DEPARTMENT OF TRANSPORTATION

Contract #: 04-0120F4Cty: SF/ALA Rte: 80 PM: 13.2/13.9File #: 69.25B**QUALITY ASSURANCE -- NON-CONFORMANCE REPORT****Location:** Changxing Island, Shanghai, PRC**Report No:** NCR-000208**Prime Contractor:** American Bridge/Fluor Enterprises, a JV**Date:** 23-Oct-2008**Submitting Contractor:** Zhenhua Port Machinery Company, Ltd (ZPMC), Changxing Island**NCR #:** ZPMC-0185**Type of problem:**

Welding	Concrete	Other	
Welding	Curing	Procedural	Bridge No: 34-0006
Joint fit-up	Coating	Other	Component: ESD1-SA97
Procedural	Procedural	Description:	East Shaft Internal Splice Plate

NON-CONFORMANCE REPORT TRANSMITTAL

简图 Sketch

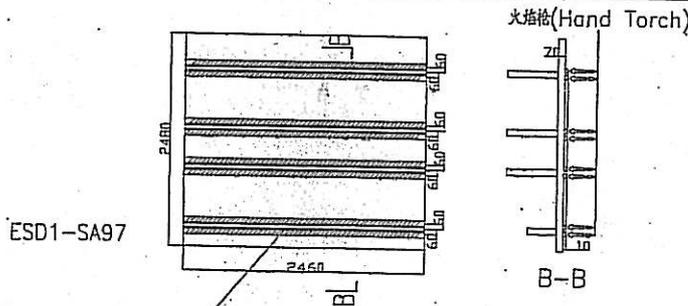
ZPMC was performing heat straightening operations to Internal Splice Plate ESD1-SA97 according to an ZPMC internal heat straightening request HSR(T)-205 which stated the maximum deformation was 10 millimeters. QA measured the member to be out of flatness to be approximately 14 millimeters as shown in the digital photograph below.

ZPMC was performing heat straightening operations to Internal Splice Plate ESD1-SA97 according to an ZPMC internal heat straightening request HSR(T)-205 which stated the maximum deformation was 10 millimeters. QA measured the member, and the deformation was approximately 14 millimeters, which is out of flatness tolerances 3/1000.

校火区域:此板最大变形量均10mm

Flame straightening area: the max deformation is about 10mm

纵向:最大校火长度均2460mm,宽度50~100mm

transverse: the max length is about 2460mm, the width is 50~100mm

注:根据实际需结合起重块进行校火

Conduct the heat straightening combining with the weight according to the actual deformed area, if necessary

ESD1-SA97

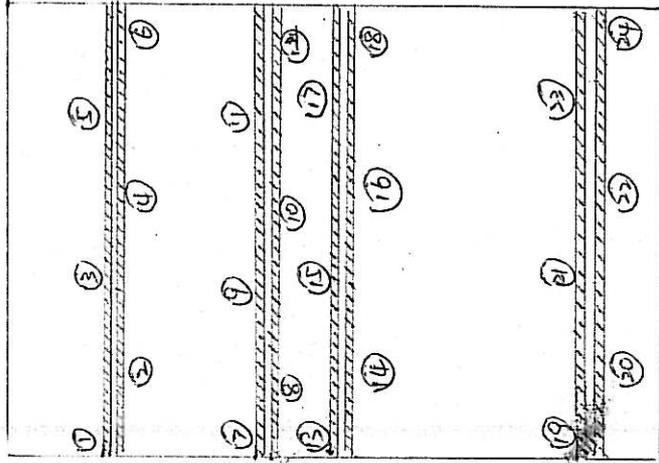
Please provide documentation to identify the requirements for straightening, and confirm that the distortion has been corrected to within acceptable dimensional tolerances. The Department will review the Contractor's proposal to close Non-Conformance ZPMC-0185 at that time.

校火前平整度测量 Flatness checking before heat straightening (mm)

测量点 Measure position	①	②	③	④	⑤	⑥	⑦	⑧	⑨	⑩	⑪	⑫
测量值 Measure result:	9.5	9.6	8.7	9.1	9.9	9.7	9.6	9.4	8.8	8.2	8.7	9.2

校火后平整度测量 Flatness checking after heat straightening (mm)

测量点 Measure position:	①	②	③	④	⑤	⑥	⑦	⑧	⑨	⑩	⑪	⑫
测量值 Measure result:	2.7	2.1	2.2	2.5	2.9	2.6	2.5	1.1	0.5	1.6	1.7	0.8

整体平整度/筋板垂直度是否合格
Heat straightening result

合格
